October 7, 1976

RE: Oconee Nuclear Station
Docket Nos. 50-269, -270, -287

KEOWEE OVERHEAD EMERGENCY POWER PATH
SEISMIC QUALIFICATION AND ANALYSIS
REQUEST FOR ADDITIONAL INFORMATION

Figure 1

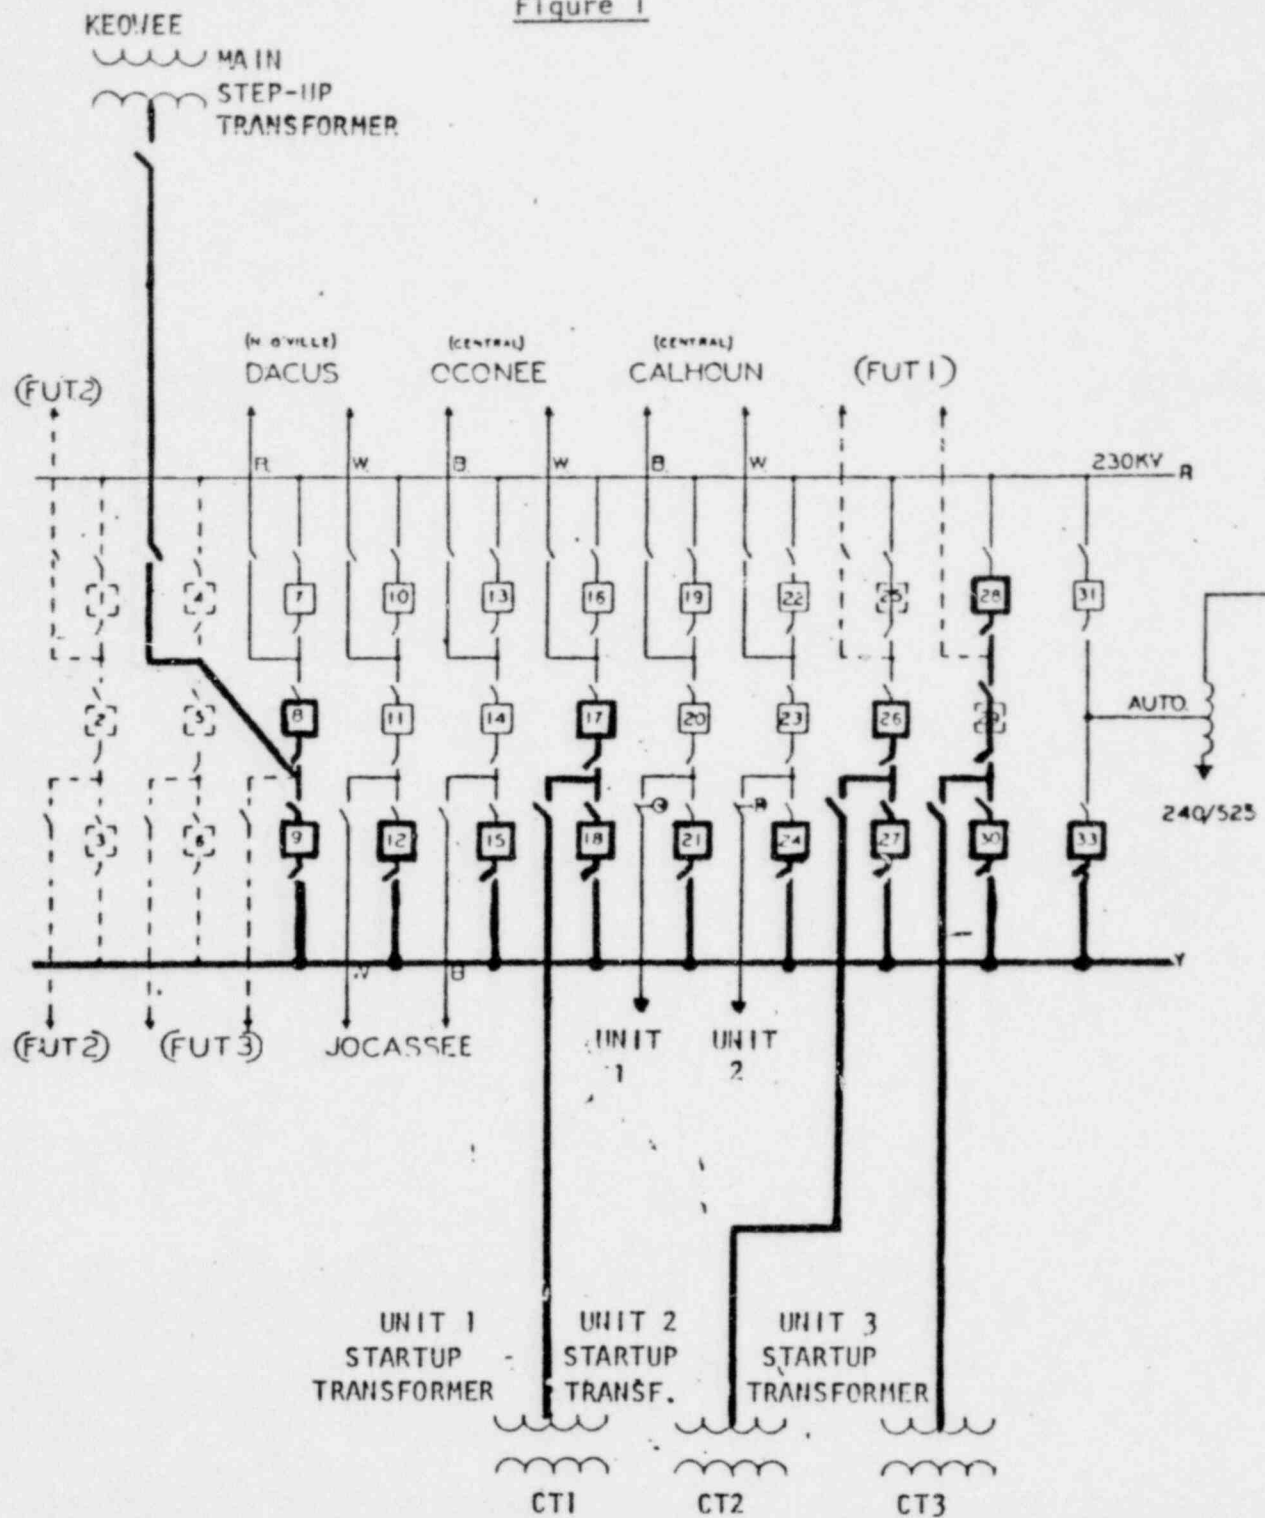
The Keowee Overhead Emergency Power Path is shown in bold lines on Figure I.
